Re: 2551 Le Jeune Road/ Publix Super Markets, Inc./ Modification of Conditions of Approval

On behalf of Publix Super Markets, Inc. (the "Applicant"), we respectfully request the following modifications to certain conditions in Resolution No. 2024-59 which approved conditional use review of a site plan and Ordinance No. 2024-11 which approved a Planned Area Development for a proposed Publix Grocery Store and Liquor Store (the "Project") to be located at 2551 Le Jeune Road (the "Property").

Exhibit “A”
UPDATED SITE PLAN, RENDERINGS, AND ELEVATIONS

**CORAL GABLES PUBLIX
STORE #84 REPLACEMENT**

C-2.1

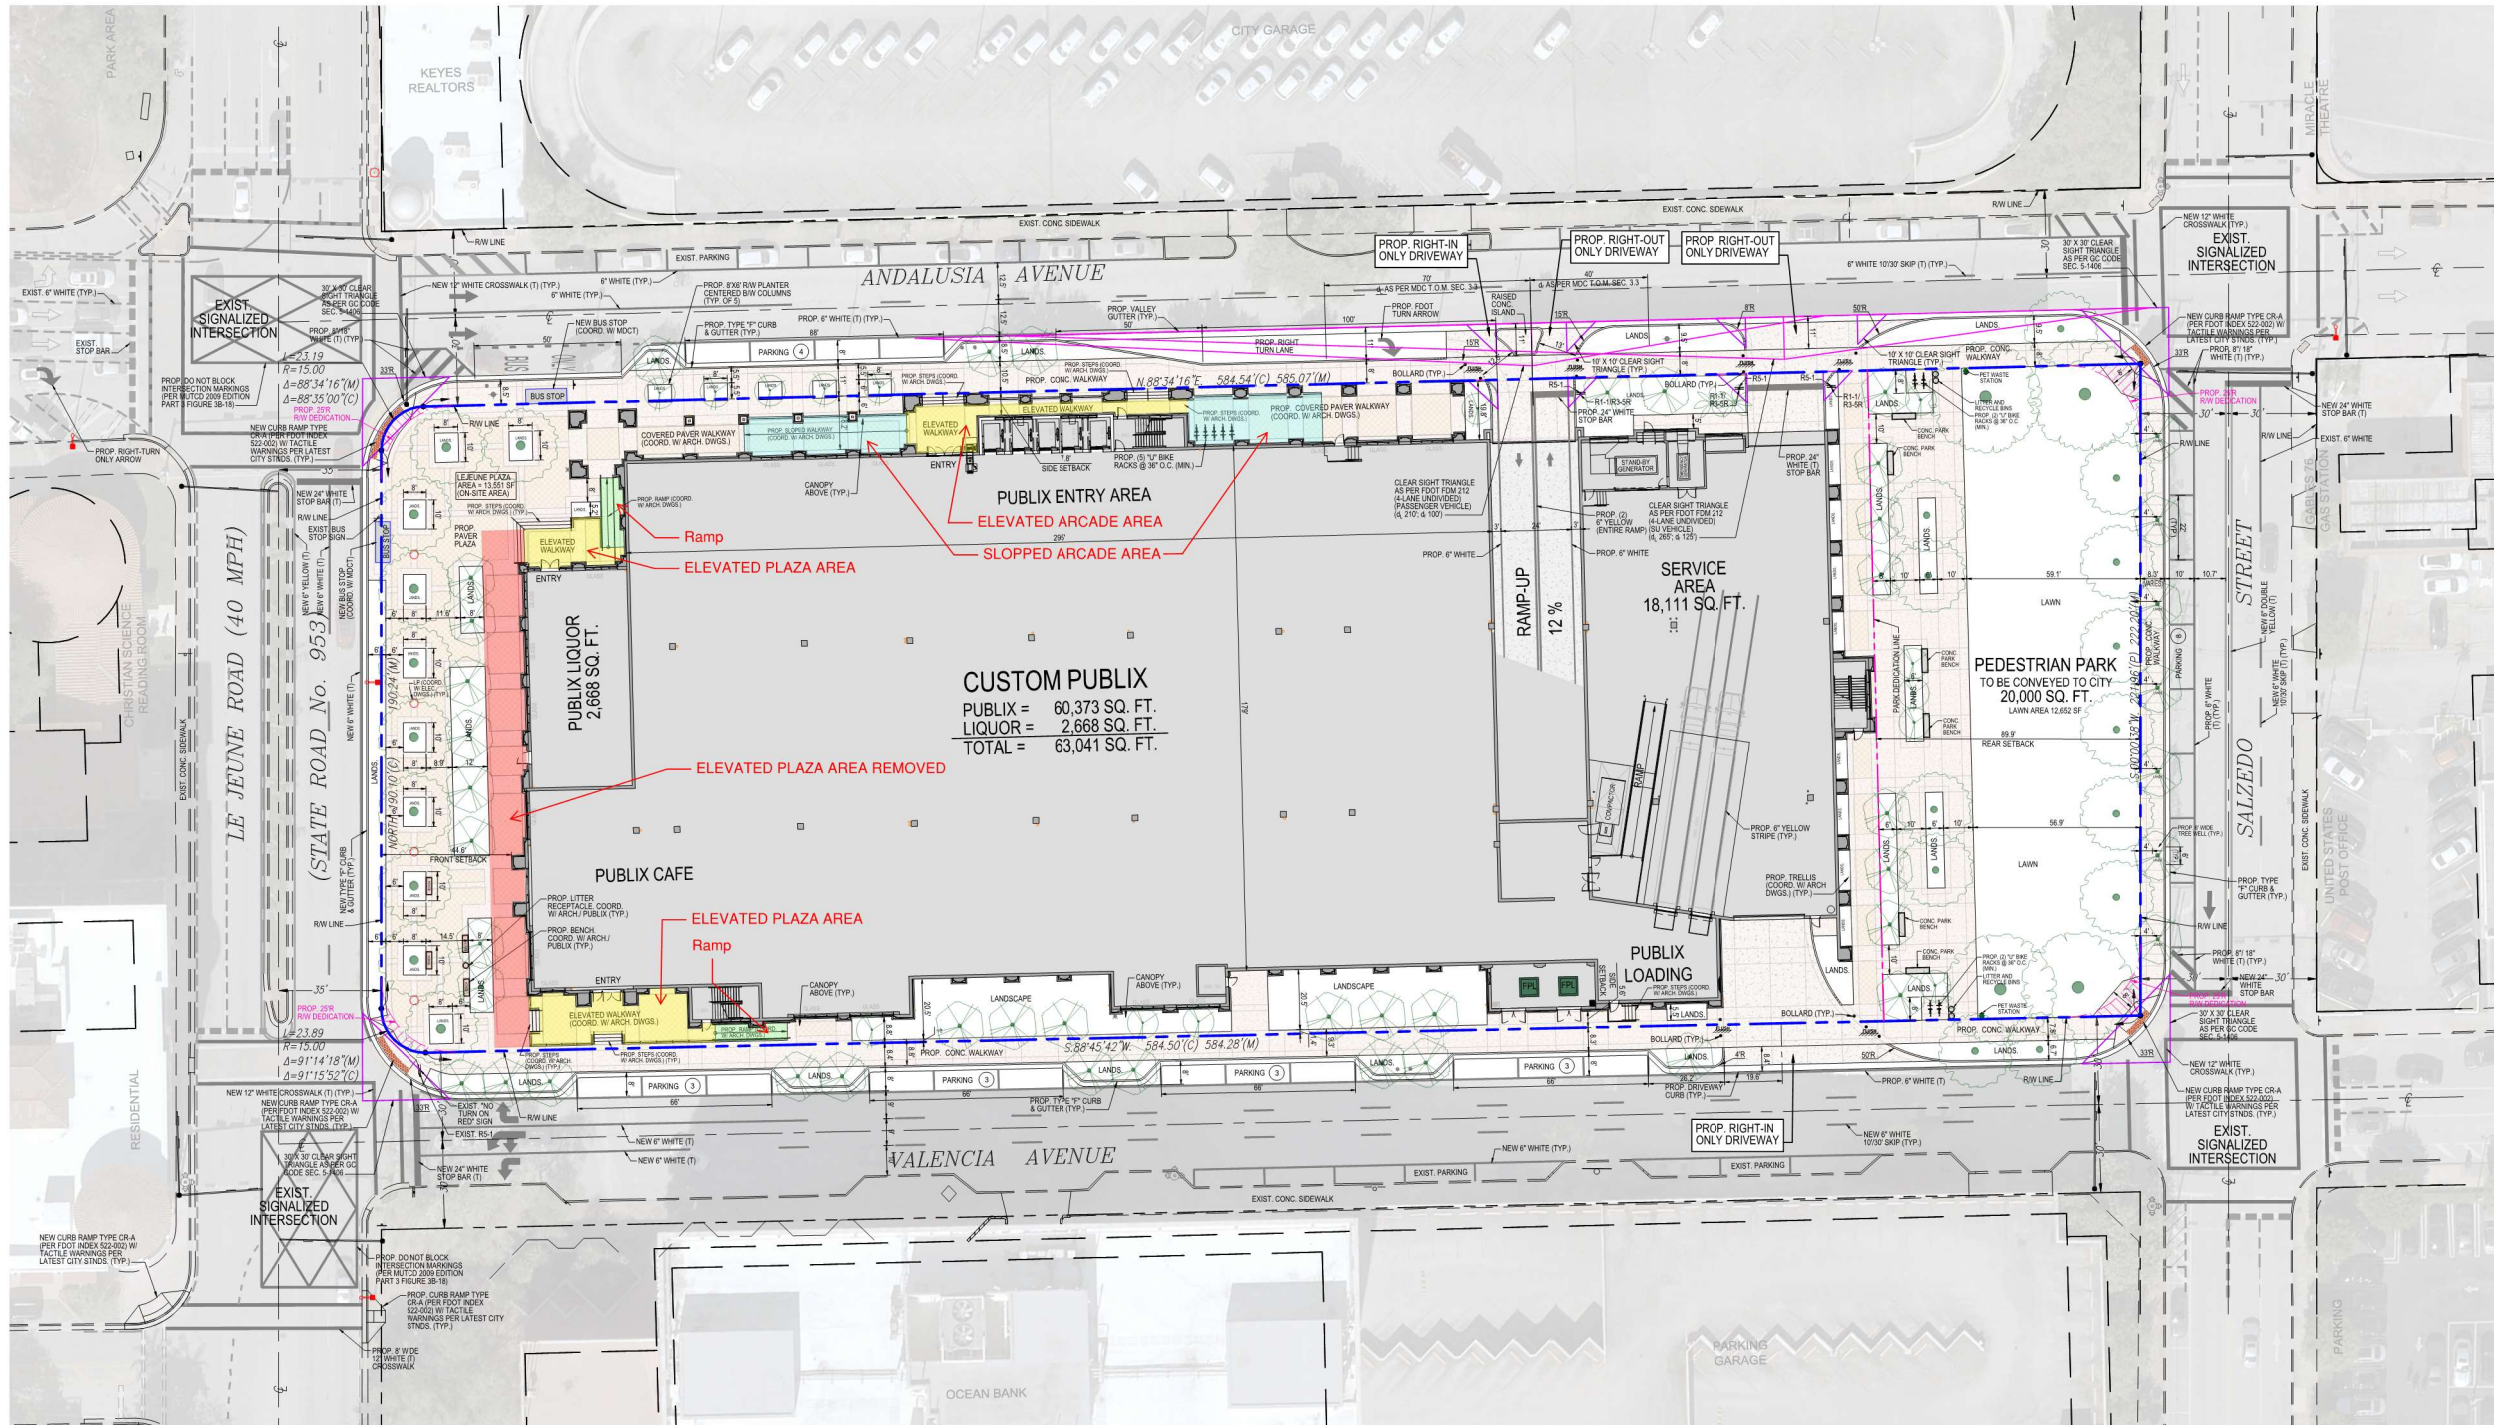
- Condition No. 1(d)(i) be replaced with an Applicant obligation that sufficient width of right-of-way be provided on Andalusia and Salzedo for future bicycle lanes to be approved in the future by both Miami-Dade County and the City of Coral Gables.

- Condition No. 1(d)(v) be revised to remove the “[r]eduction of travel lanes on Valencia” and the “dedicated northbound left turn lane on Salzedo at Valencia” conditions.

Enclosed with this letter are the updated site plan and renderings indicating where ramps and stairs have been introduced, along with elevations reflecting the slightly increased heights required to meet flood elevation standards (**Exhibit “A”**). Also included, for comparison, are the previous renderings (**Exhibit “B”**). Additionally, enclosed is a copy of the memo from the Miami-Dade Public Works Department summarizing their comments to the proposed off-site traffic improvements (**Exhibit “C”**). Please schedule this request for review and consideration by the City Commission at its April 14, 2026 meeting. If you have any questions, please do not hesitate to contact me at (305) 376-6061. Thank you for your attention to this matter.

CORAL GABLES PUBLIX #84 REPLACEMENT CORAL GABLES, FL
DESIGN DEVELOPMENT VALENCIA AVE. & LE JEUNE RD.

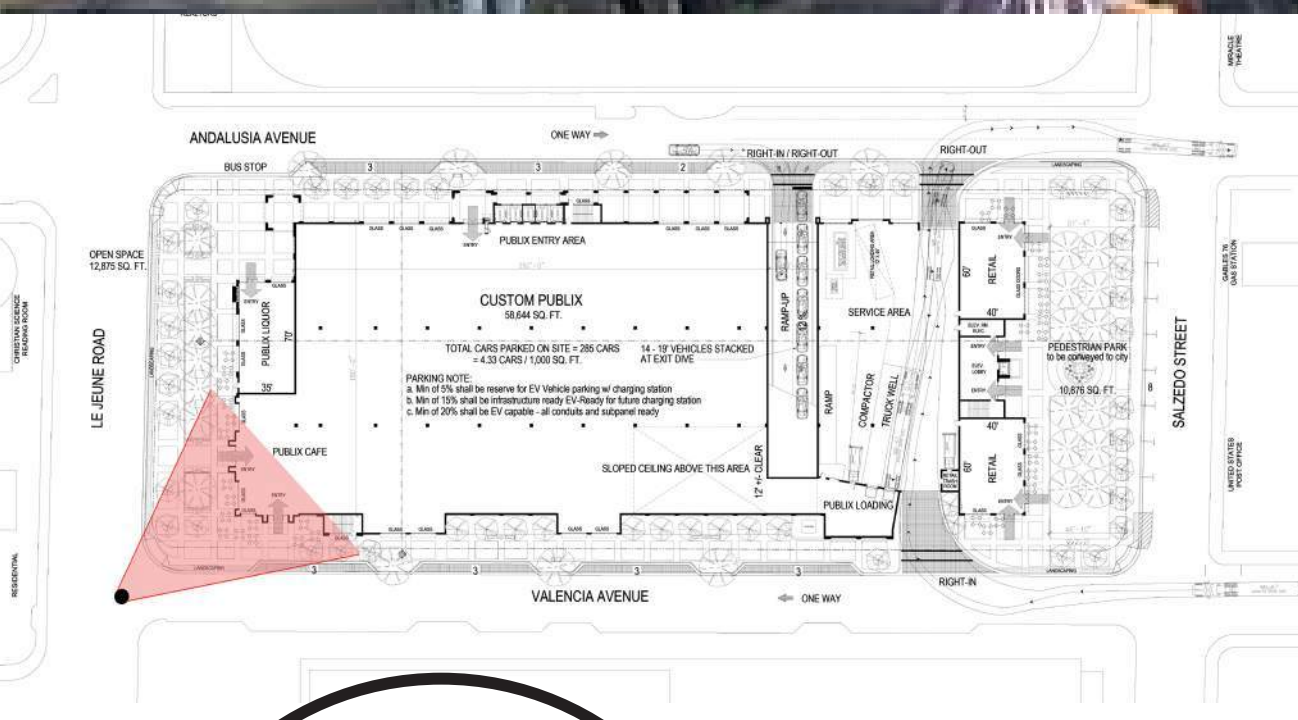
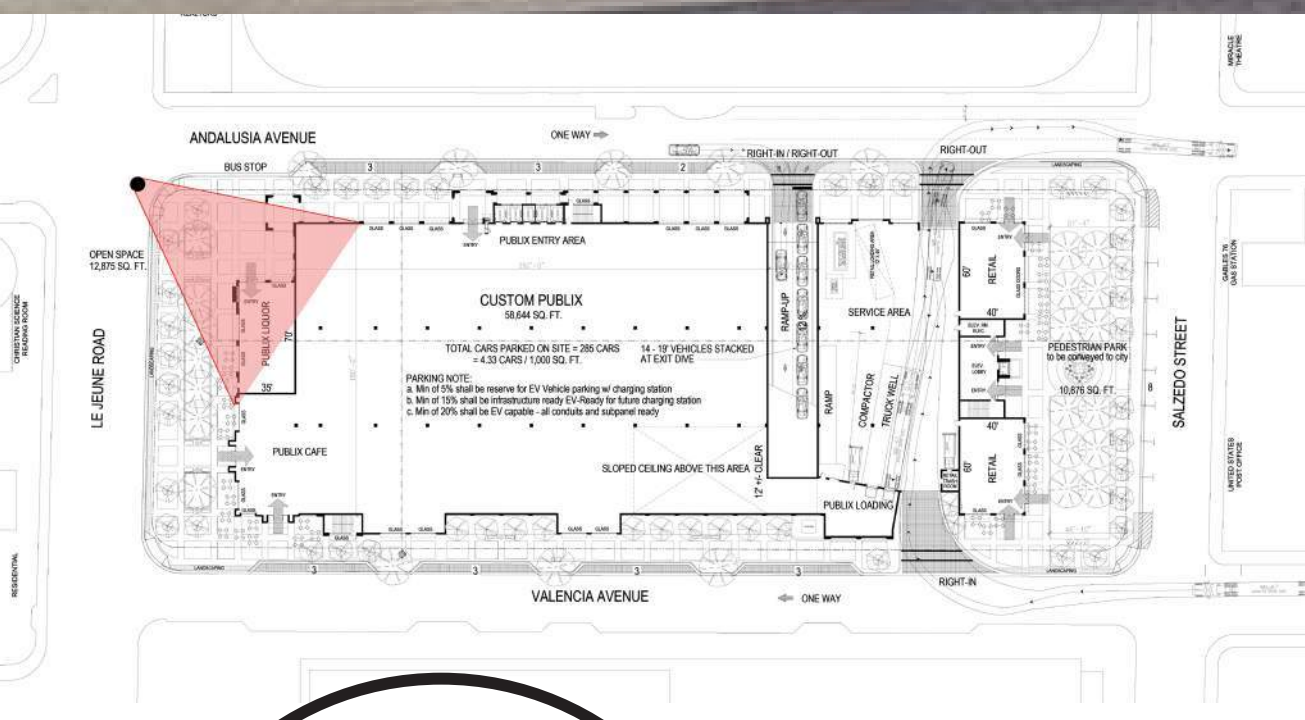
- Condition No. 1(a)(i) be replaced with an obligation that the maximum building height including all architectural features shall not exceed 67 feet.
- A new Condition No. 1(a)(v) to reference the updated plans, elevations, and renderings prepared by Fisher Architects dated March 12, 2026.
